REQUEST

Current Zoning: R-3 (single-family residential) and R-12(CD) (single-family residential, conditional)
Proposed Zoning: R-12MF(CD) (multi-family residential, conditional)

SUMMARY OF PETITION

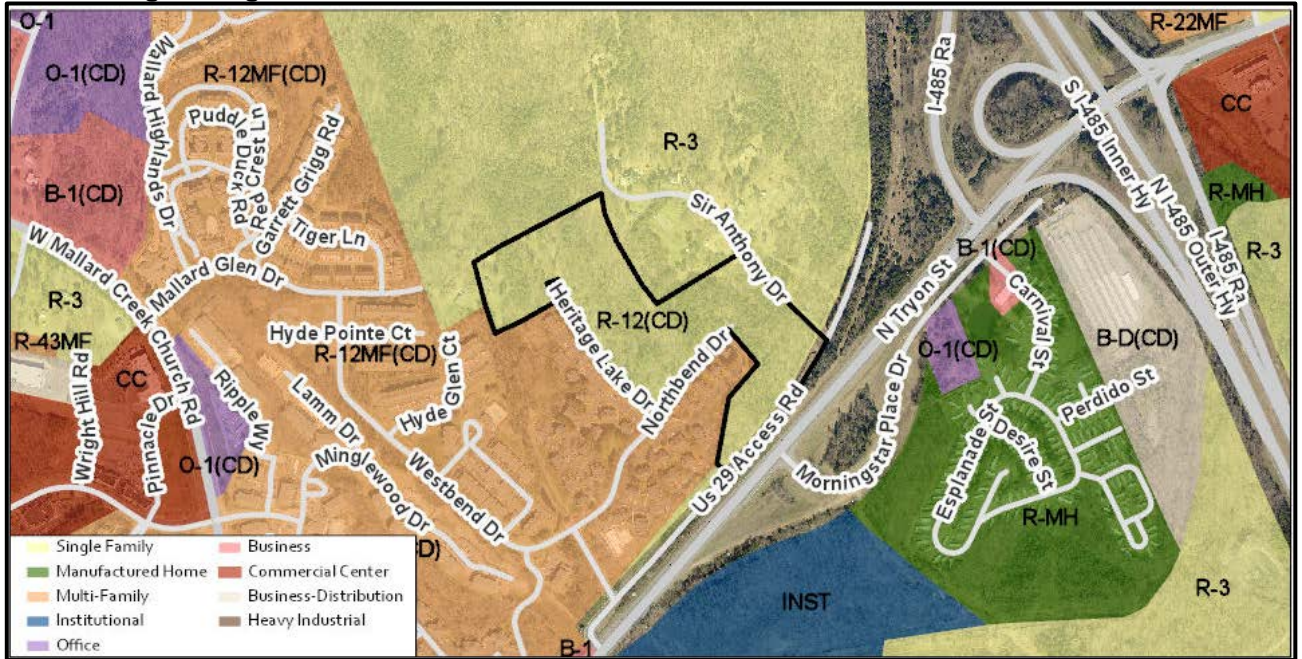
1. Show the curb and gutter labeled and dimensioned from the centerline for each road.
2. Correct spelling error for proposed back of curb; petitioner should update to show proposed and not "roposed" on both US 29 Access and Sir Anthony Drive.
3. Update the site plan to update the note to remove condition of "cost of the extension" as reason to not extend. CDOT is understanding of the necessity to fit sidewalk within the existing R/W.

4. Revise or delete note 5g as it is not a clear commitment.
 5. Remove the row of parking facing Sir Anthony Drive in front of the leasing office.
 6. Insure entrance gate shall be a minimum of 40-feet away from access road.
-
